**Subject:** Material for today's Light-duty GHG NPRM discussion.

# Summary points from EPA review of CAFE model (NPRM version) – Effect of EPA code revisions

# EPA Initial Review of CAFE Model & Inputs, February 9, 2018

# Growth in Fleet Size Due to Scrappage Model

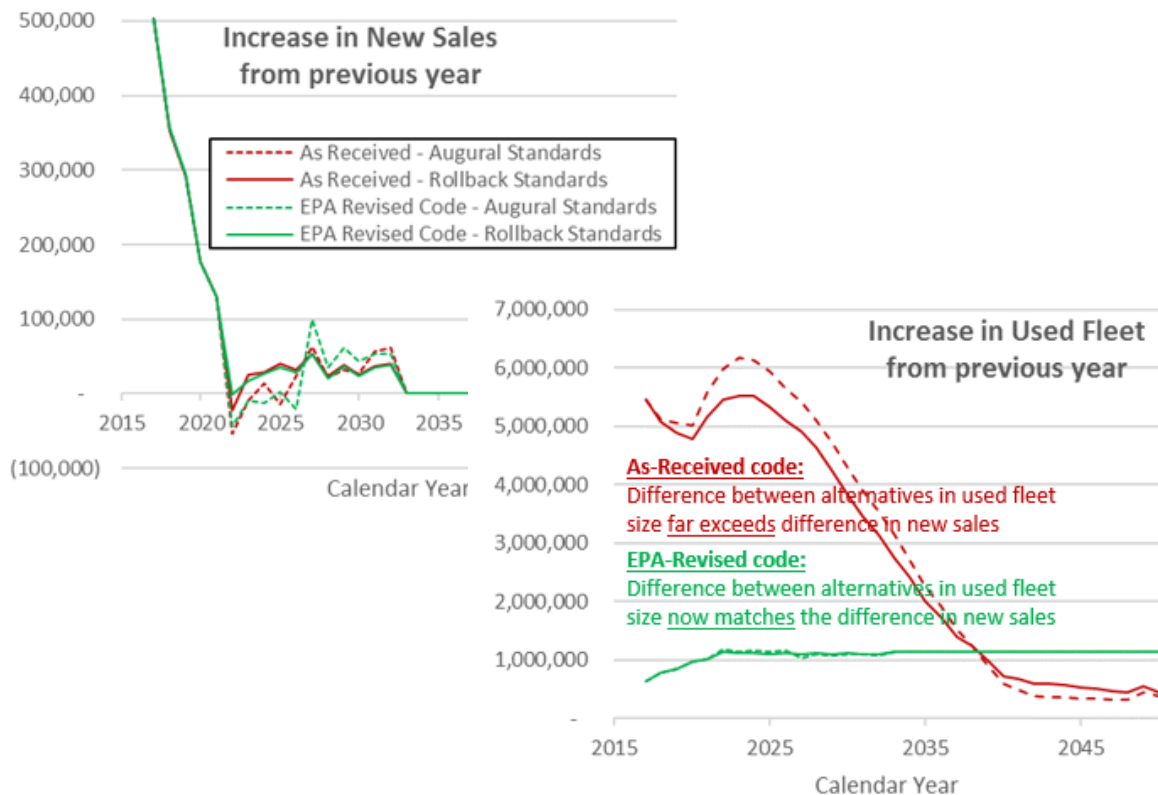
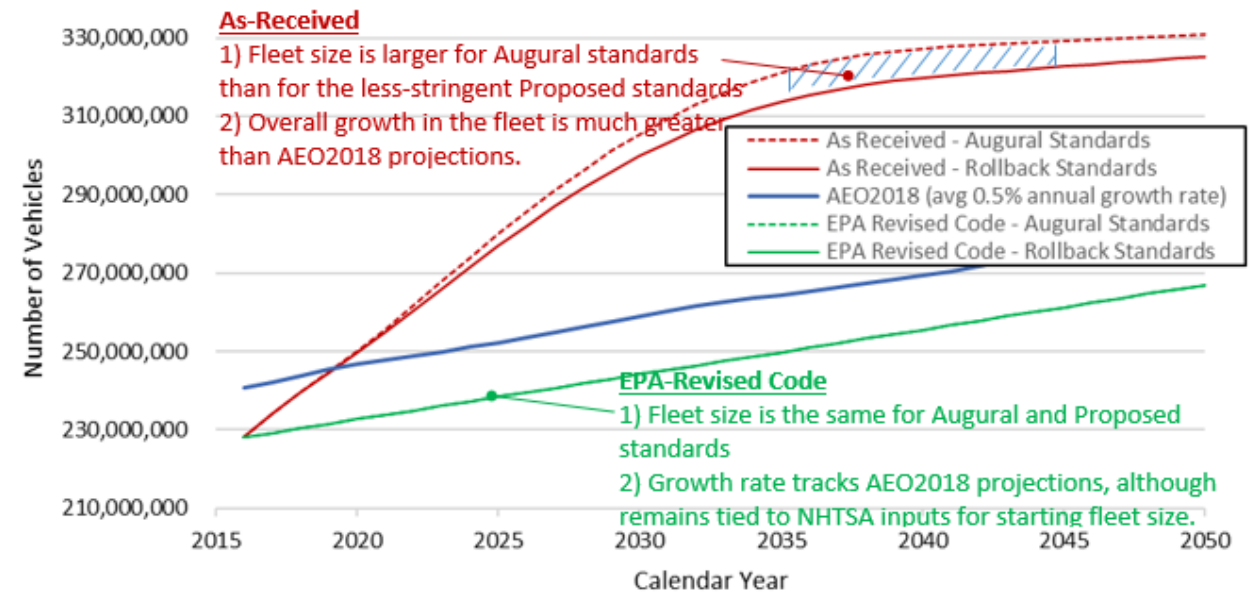
The new vehicle sales model produces small reductions in projected sales under the Augural standards, while the scrappage model projects an increase in fleet size that far outweighs the sales reductions (by a factor of 60:1.) The combined result is a fleet size that grows much more rapidly than AEO projections.

Specific the overall fleet growth as an input, and scale the scrappage rate curves (maintain the new sales model as is)

# Growth in VMT beyond the intended rebound-related increase

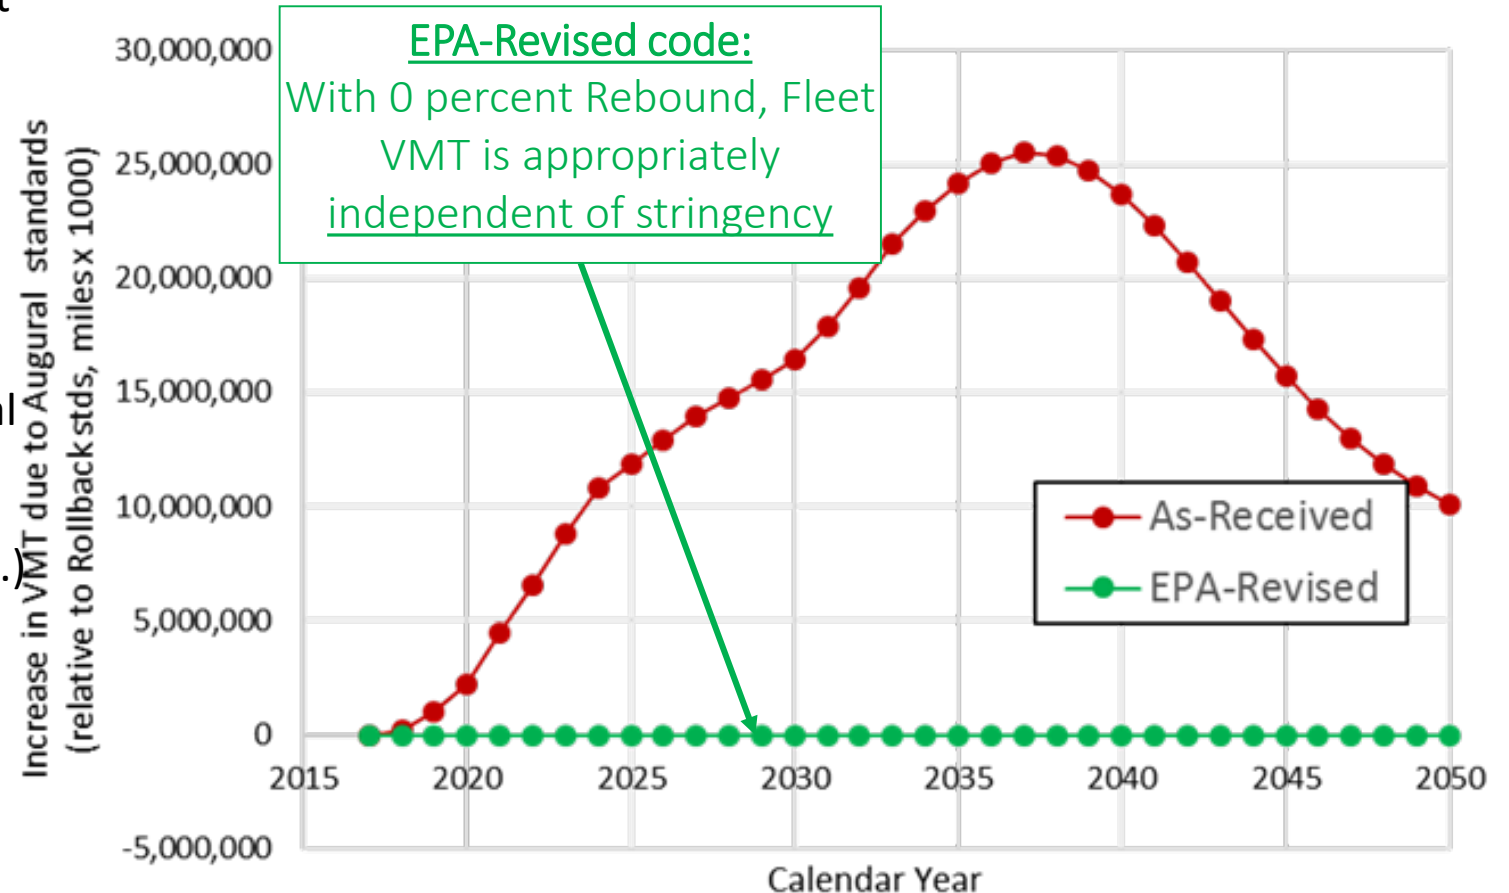
Per-vehicle VMT schedules are fixed, and not dependent on the scrappage model. As a result, total VMT can vary in an unexpected/unintended ways (e.g., VMT changes with zero rebound, zero rebound growth more expensive new and used vehicles.)

Scale per-vehicle VMT schedules so that total VMT is consistent with definition of rebound (i.e. Total VMT remains constant across regulatory alternatives at 0 percent rebound.)

**Figure 2 Year-over-year increase in new vehicle sales (left) and increase in used fleet size (right) using As-Received CAFE model (note the difference in y-axis scale)**

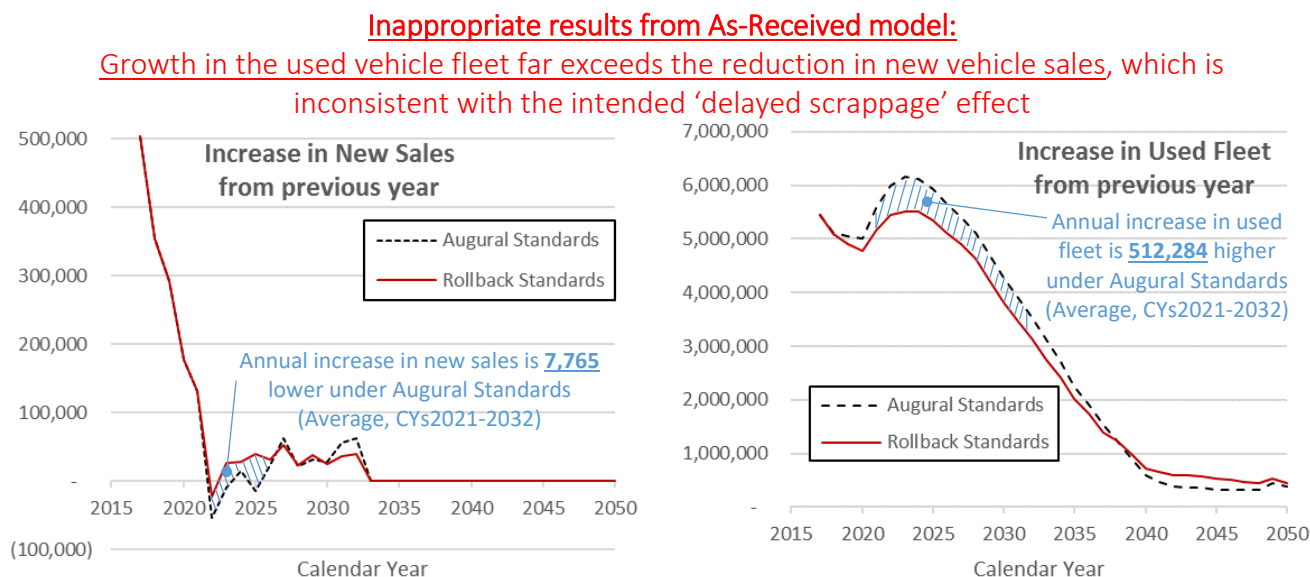
While directionally those trends are logical, the difference in the magnitude of impact the Augural standards have on the new sales and scrappage models is difficult to justify. The As-Received model estimates that the Augural standards will reduce the year-over-year annual increase sales of new vehicles by approximately 8,000 vehicles on average between CY2021 and CY2032. However, during the same period, the As-Received model estimates that the used fleet will grow by an average of 512,000 vehicles per year, far exceeding the decrease in new vehicle sales. It's hard to imagine any real-world scenario under which over 60 additional used vehicles are retained for each new vehicle that the sales model predicts will be unsold as a result of the higher new vehicle prices.

**Figure 3 Total fleet size in As-Received CAFE model (AEO 2018 0.5% growth rate shown for reference)**

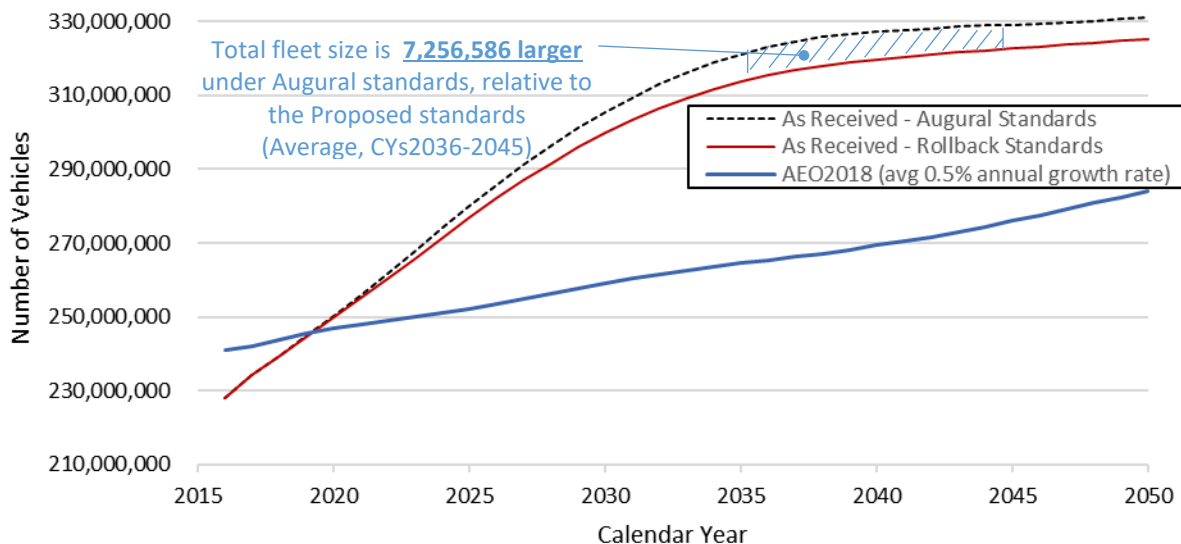
Figure 3 shows the combined effect of the new vehicle sales model and the scrappage model in the As-Received version of the CAFE model. A change in the overall fleet size due to the Augural standards might not in and of itself be problematic, as long as the VMT schedules are adjusted to account for overall travel activity that is distributed over a larger number of vehicles. However, the As-Received version of the model does not adjust VMT schedules, with the result that the additional unscrapped vehicles inflate total VMT proportionately. During the period over which the summary statistics for fatalities are reported in the draft NPRM (CYs 2036-2045), the difference in the estimated fleet sizes between the Augural and Proposed standards is approximately 7 million vehicles, or over 2% of the

**Total Fleet size grows with increases in stringency and cost of new and used vehicles, which is not consistent with the basic principle of supply and demand**

EPA modified the CAFE model to align with the NHTSA’s stated intent, so that the scrappage model predicts fleet composition, but does not dictate total fleet size. Our modified code allows the user to select a fleet growth rate (we have used the AEO value of 0.5% growth per year by default, but other rates could be used.) Our code then allows the model to run as usual to determine new vehicle sales and the composition of the used vehicle fleet. These values are then used to scale the size of the used vehicle fleet (maintaining the predicted composition) to achieve the user-provided growth in fleet size. This way the new vehicle sales are identical to the As-Received values, the used vehicle fleet has the identical composition as the As-Received values, but the fleet size grows at much more reasonable rates.

**Figure 4 Change in VMT due to 20 percent rebound with As-Received model, Proposed standards case (change shown is relative to 0 percent rebound)**

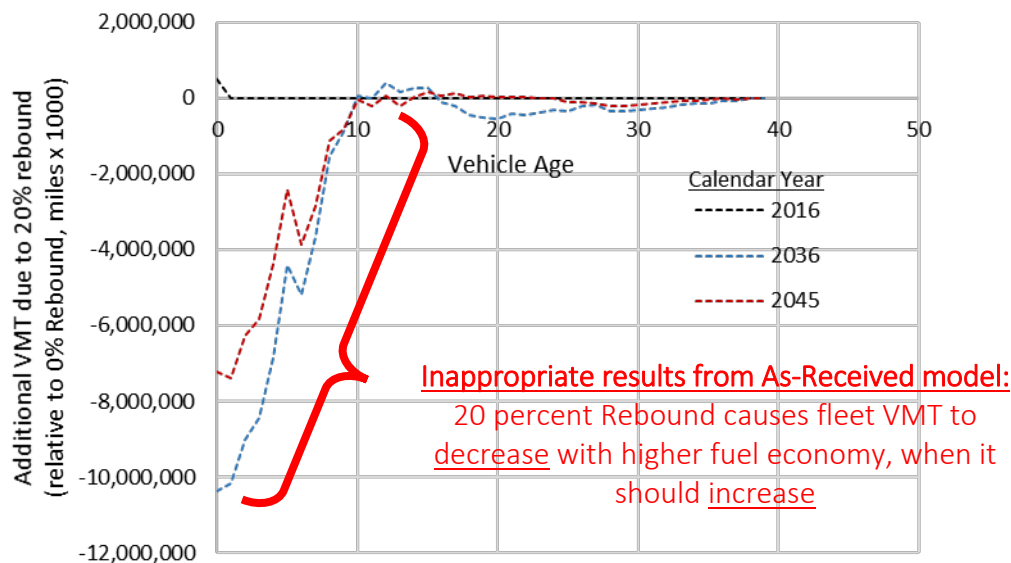
One of the problems with the implementation of the rebound calculations in the code of the As-Received model is illustrated in Figure 4 for the Proposed standards. In this case, the inclusion of 20 percent rebound causes a reduction in VMT in future calendar years, despite the fact the Proposed standards produce a fleet with higher fuel economy and lower cost per mile than the baseline (MY2016) fleet. This result is clearly inappropriate, since by definition the rebound effect should result in more miles driven as cost per mile decreases.

Figure 5 CPMrate variation by vehicle age and fuel economy improvements during redesign of 10 percent (left panel) and 50 percent (right panel)

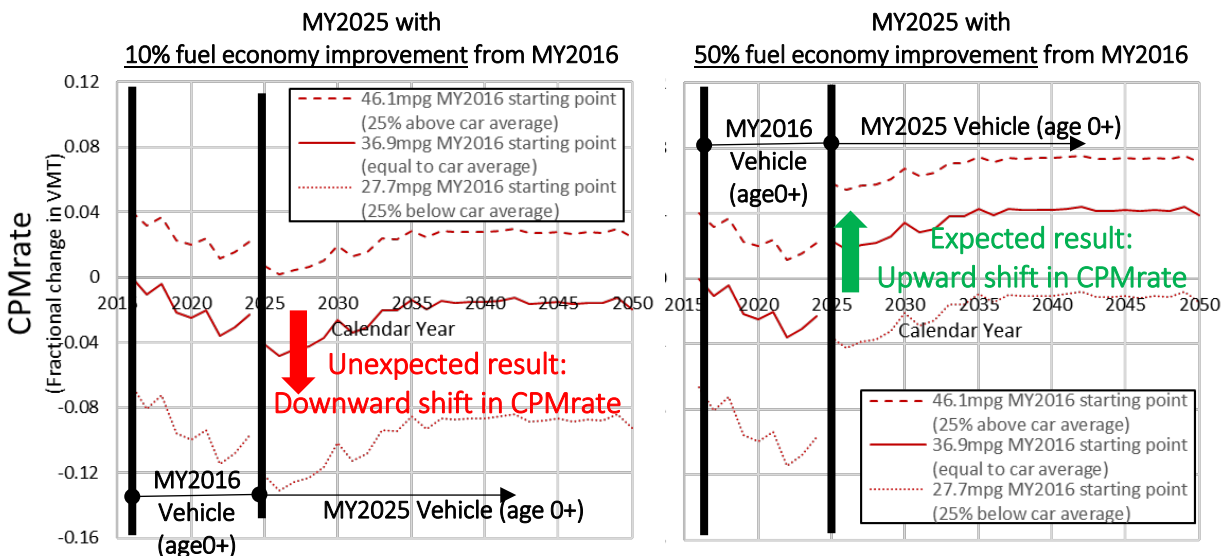
Figure 5 gives a closer view of the CPMrates determined from Equation 1 for three example vehicles, with MY2016 versions which maintain a constant fuel economy at levels equal to, 25 percent above, and 25 percent below an average MY2016 car.<sup>9</sup> These values are maintained until a MY2025 redesign, when the fuel economy is improved by either 10 percent (left panel) or 50 percent (right panel) compared to the MY2016 versions.

One notable observation is how the CPMrates vary by calendar year as the individual vehicles age. This is unexpected, since the CPMrate is applied to the annual mileage values that already account for the progressive decline in the miles driven each year as vehicles age. What the age- or year-related phenomenon this variation in CPMrate would be intended to represent is not clear. Another notable observation is the inconsistency in the direction of change in CPMrate of the new MY2025 vehicle, relative to the 8-year old MY2016 vehicle in CY2024. When the MY2025 vehicle is 50 percent more fuel efficient than MY2016 (right panel of Figure 5), the CPMrate shifts upward, resulting in higher VMT for the vehicle with greater fuel economy as would be expected. However, when the MY2025 vehicle is only 10 percent more fuel efficient than MY2016 (left panel of Figure 5), the CPMrate shifts downward. This tendency to produce VMT reductions for newer vehicles with moderate levels of fuel economy improvement is consistent with the inappropriate VMT results shown in Figure 4 above, indicating that this issue is caused by the calculation of CPMrate within the CAFE model.

**Figure 6 Change in VMT due August standards, with 0 percent rebound (relative to Proposed standards)**

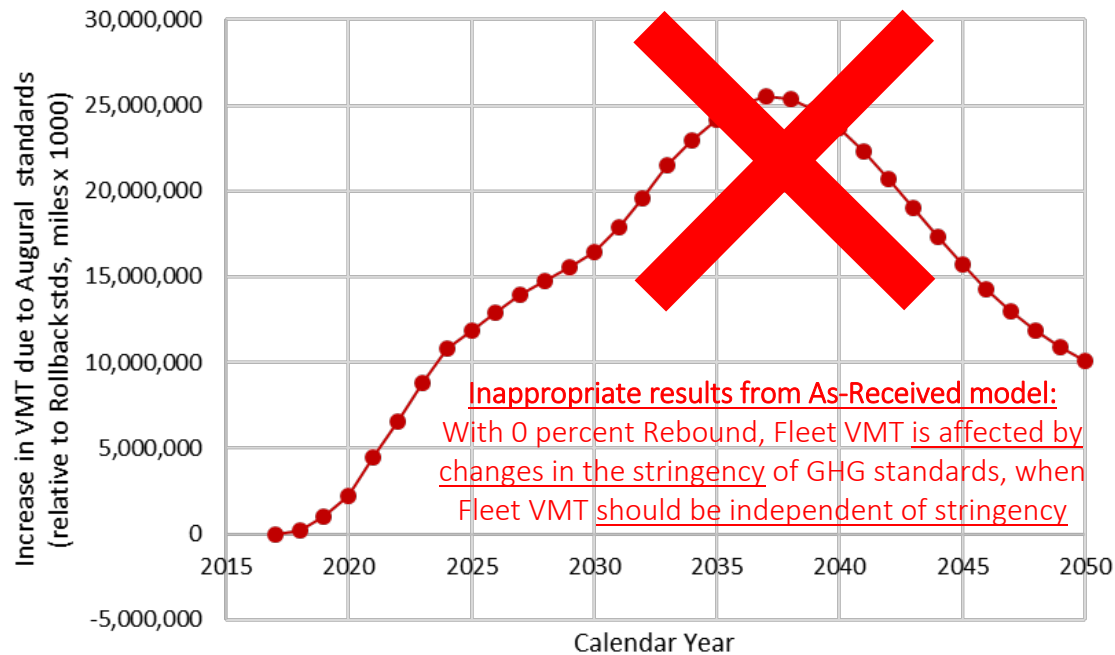
In addition to the problems described above with the As-Received model's implementation of the rebound effect, an additional inconsistency between VMT estimates generated by the model and the specified rebound value became evident when we looked at the VMT results for alternatives with different stringencies, holding rebound at 0 percent.<sup>10</sup> With no rebound, we would not expect to see any change in total VMT, since by definition rebound is measured as the change in VMT for a given change in fuel cost per mile. However, even with 0 percent rebound, the As-Received model does produce total VMT values that are influenced by stringency level. See Figure 6, below. We believe that this zero-rebound VMT growth is an artifact of the disconnect between the sales model, scrappage model and mileage accumulation schedules described with Issue #1. And while this problem is not directly related to the model's calculation of the rebound effect, it points to the importance of carefully considering how the various elements are integrated when making changes or additions to a model.

In total, the As-Received model 1) inappropriately incorporates a vehicle age-related effect due to rebound, 2) exhibits directionally incorrect VMT changes in response to fuel economy improvements, and 3) produces a VMT response to changes in stringency even when the rebound value is set to 0. We conclude that the model's implementation of the rebound effect is inappropriate, and that the model code produces VMT values that are inconsistent with the 20 percent rebound value that is specified in the input files. As with the problems described for the Scrappage Model in Issue #1, resolving the problems with the CAFE model's implementation of the rebound effect is critically important. An inappropriate accounting of the rebound effect will produce unreliable VMT estimates, which in turn will produce unreliable estimates of net fuel savings, emissions costs, fatalities, etc., making it impossible to accurately evaluate and compare the various policy alternatives.

**Figure 7 Effect of CPMref assumptions on CPMrate with 20 percent rebound (hypothetical example shown for MY2025 vehicle with 10 percent fuel economy improvement from MY2016 vehicle)**

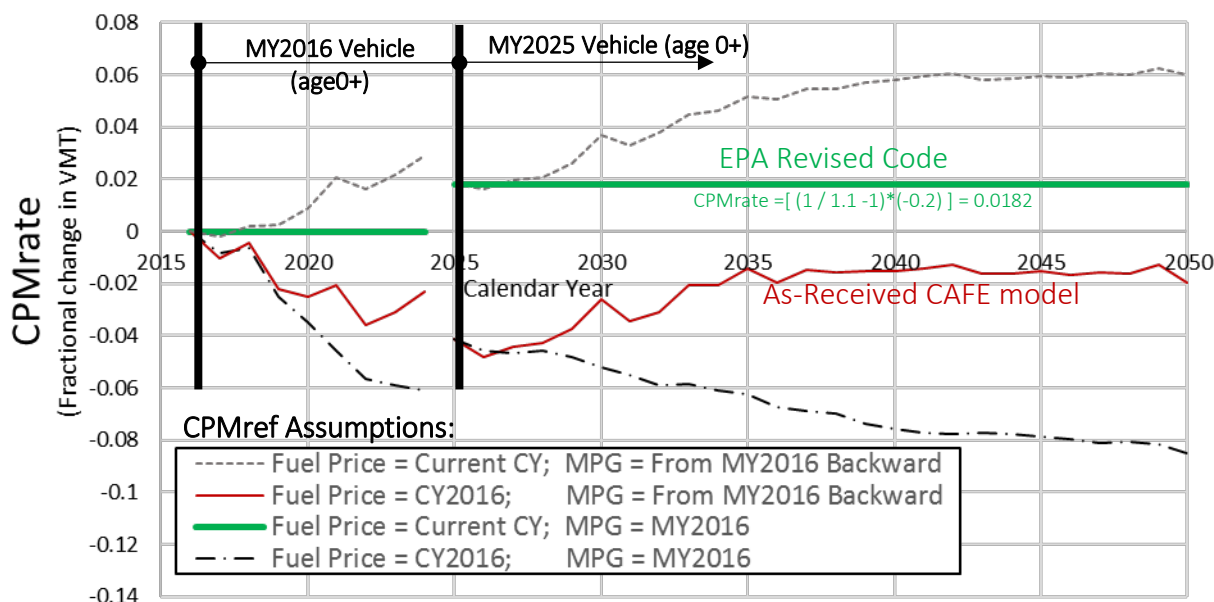
A hypothetical example will help to illustrate the importance of making appropriate assumptions when selecting CPMref. Building off the example in Figure 5 with MY2025 improvements to an average MY2016 car with fuel economy of 36.9mpg, Figure 7 shows how the CPMrate (and therefore the VMT) can change dramatically based on assumptions for CPMref. The inappropriate referencing of progressively older fleet average fuel economy values (red and gray curves), causes the CPMrate to be higher than when constant MY2016 reference fuel economy values are used (black and green curves.) The inappropriate referencing of CY2016 fuel prices (red and black curves) causes the CPMrate to be lower than when the current CY fuel prices are used (gray and green curves.) While these two problematic assumptions for CPMref tend to work in opposite directions, the general tendency of the As-Received model to produce a negative CPMrate in the example in Figure 7, despite the improvement in fuel economy, seems to indicate the assumption of maintaining CY2016 fuel prices is dominant.

We believe that the most defensible implementation of the rebound effect is one that maintains the same CPMrate over every calendar year in the course of a vehicle lifespan. In the example shown by the green line in Figure 7, the CPMrate for the MY2025 vehicle then becomes simply a function of the ratio of the reference fuel economy to the new fuel economy and the 20 percent rebound effect value, or  $[(1 / 1.1) - 1] * (-0.2) = 0.0182$ . To achieve this, we revised the CAFE model code so that:

**Figure 8 Cost and Effectiveness of MY2030 vehicles relative to a 'null' tech package (PEV's are off chart area, but included in fleet average)**

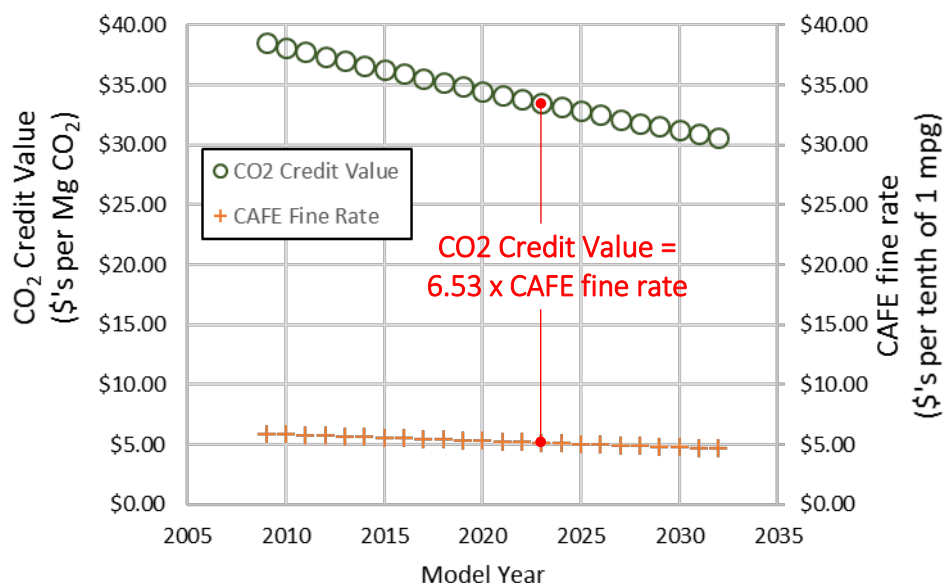
Figure 8 shows the total technology cost and effectiveness for all technology packages applied by the As-Received CAFE model to the MY2030 fleet, relative to a ‘null’ package with only basic technologies.<sup>12</sup> While we would not expect manufacturers to consistently apply technology packages that lie exactly on the cost-efficient ‘frontier’, the frequency with which the As-Received CAFE model applies packages that are several thousand dollars more expensive than other available packages is striking.

To resolve the issue of the cost-ineffective technology application decisions, EPA revised two elements of the CAFE model code. First, we revised “efficiency” calculation used for package ranking. Because we don’t believe that the value of a CO<sub>2</sub> credit to any manufacturer can be reasonably determined in advance<sup>14</sup>, we have removed the monetary valuation of CO<sub>2</sub> credits from the numerator of Equation 3, and instead include the change in quantity of compliance credits (in grams CO<sub>2</sub>) as a normalizing factor in the denominator of the efficiency calculation. The modified calculation, shown as Equation 6, can be interpreted as the cost-efficiency of a technology application in terms of the net cost per gram CO<sub>2</sub> credits earned. We think that this decision rule would reasonably represent a manufacturer that is applying technologies in a cost-minimizing manner, subject to all the original constraints on technology availability and redesign cycles specified in the As-Received CAFE model input files. As with the As-Received CAFE model logic, our revised code prioritizes technology packages with more negative efficiency values.
